Detailed Site Plan Cherry Lane Storage

DSP-22007

SUBJECT: Detailed Site Plan DSP-22007
Type 2 Tree Conservation Plan TCP2-020-2022
Cherry Lane Storage

TYPE II TREE CONSERVATION PLAN

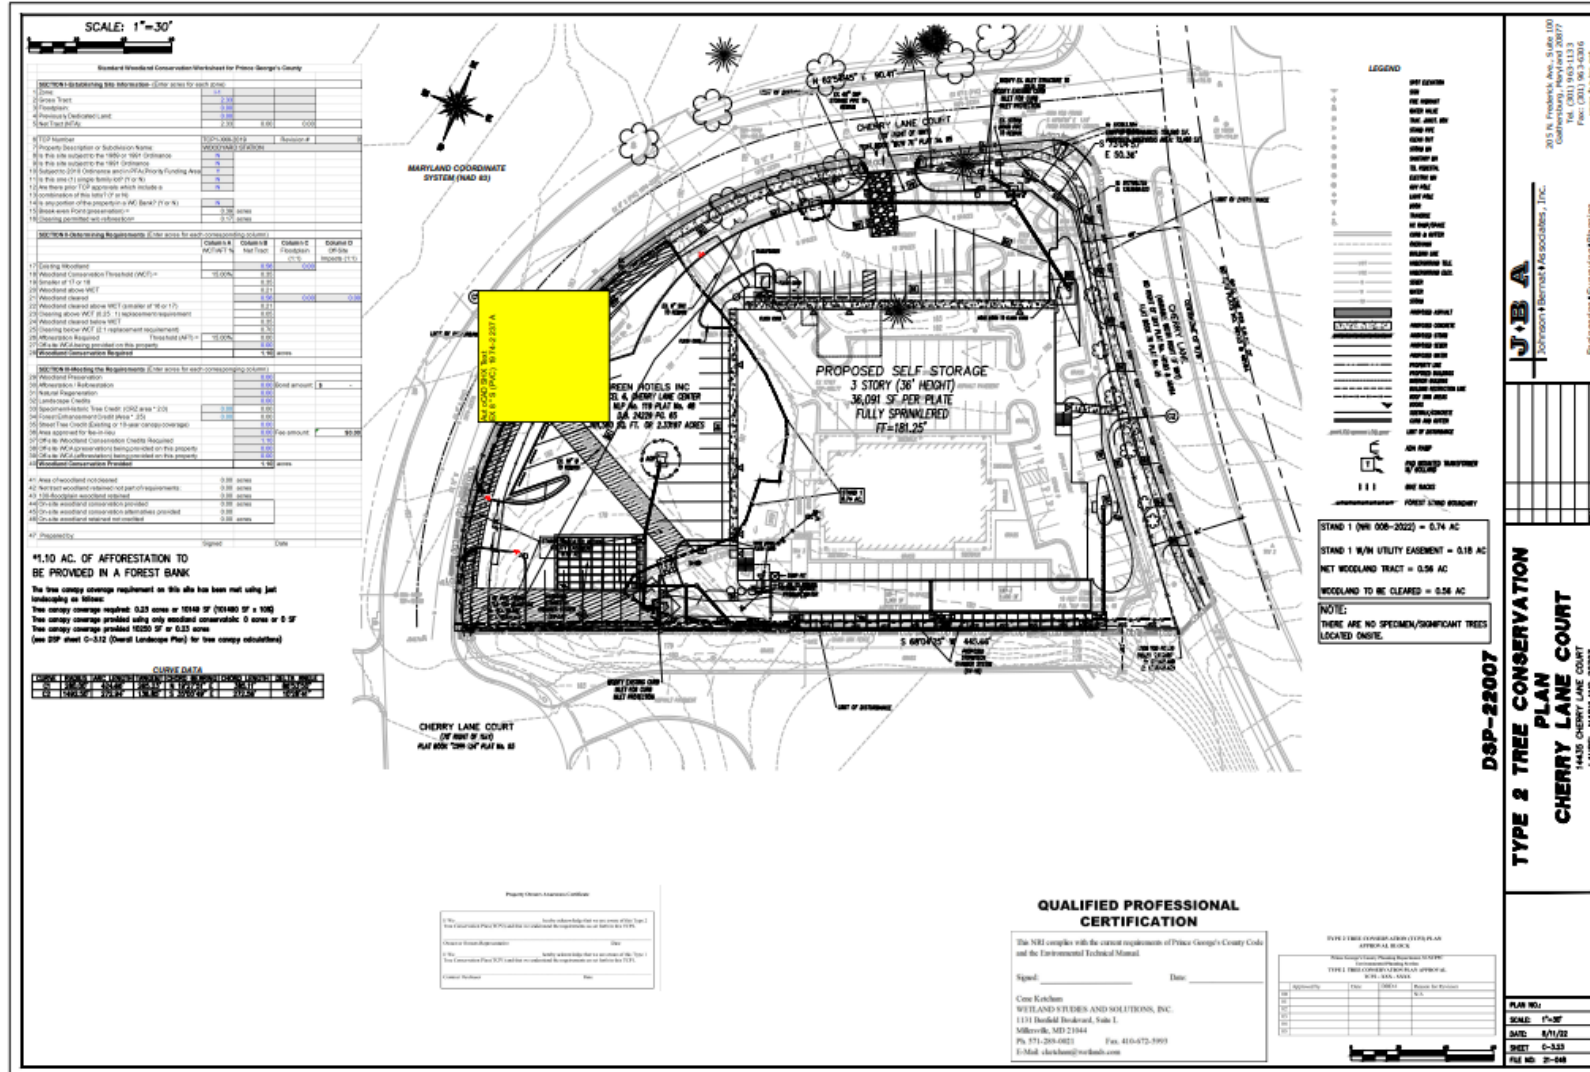
It was noted that the woodland net tract value (0.54-acre) in the site statistics table on Sheet 1 of the TCP2 is inconsistent with the TCP2 worksheet and associated table on Sheet 2 (0.56-acre). Furthermore, both of these values are inconsistent with the woodland net tract value (0.74 acre) in the site statistics table on the approved natural resources inventory

(NRI). An extra line was added to the site statistics table on the TCP2 entitled “woodland in a utility easement” for the area of existing woodlands within the public utility easement, which appears to have been incorrectly deducted from the total existing woodland area to give these inconsistent net tract area values. The standard approved site statistics table format must be used on the TCP2. The existing woodland net tract value on the approved NRI (0.74-acre) must be reflected in all tables and in the TCP2 worksheet. The proposed woodland clearing value must be adjusted accordingly and calculations rerun in the TCP2 worksheet.

- c. Make the following changes to the standard TCP notes on Sheet 1:
 - (1) Revise General Note 6 to state that "The property is within Environmental Strategy Area 2 (formerly the Developing Tier). This site is currently zoned Industrial, Employment (I-E). However, the applicant has opted to apply the zoning standards to this application that were in effect prior to April 1, 2022, for the Light Industrial (I-1) Zone."

- (2) Add standard General Note 9 to the TCP2 plan.
 - d. Revise the Site Statistics Table on Sheet 1 to match the required standard table format, per the 2018 *Environmental Technical Manual*.

- e. Revise all references to woodland net tract value on the TCP2 to match that of the approved natural resources inventory.
 - f. Revise the TCP2 worksheet, as follows:

- (1) Add the correct TCP number to the worksheet.
 - (2) Add the correct project name in the "Property Description" or "Subdivision Name" box.
 - (3) Update the net tract value and revise the calculations.

- g. Remove all tree canopy coverage notes from the TCP2.
- h. Remove the Curve Data table from the TCP2.
- i. Darken the proposed building footprint and the proposed parking and circulation linework on each sheet of the TCP so they are clearly distinguishable from the existing building and parking.
- j. Add the TCP2 case number (TCP2-020-2022) to the TCP2 Environmental Planning Section approval block.
- k. The qualified professional must sign and date their certification on the TCP2.
